| Model | PDC-10E I/F kit type B | Volt/Hz | Date of Modification | Serial Number |
| Reason for Modification | To comply with CE mark standards. | | | |

| Model | Interface Kit Type B | Volt/Hz | Date of Modification | Serial Number |
| Reason for Modification | To reduce noise emission | | | |

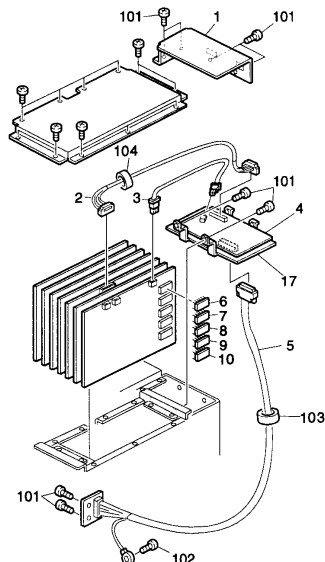
To comply with the CE mark standards, ferrite cores have been added.

| New P/N | Description | Q'ty Used | Parts Catalog | |
|----------|------------------------------|-----------|---------------|------|
| 16070534 | Ferrite Core - ZCAR3035-1330 | 0 → 1 | 103 | 3 |
| 16070638 | Ferrite Core - TFC25-15-12 | 0 → 1 | 104 | 3 |
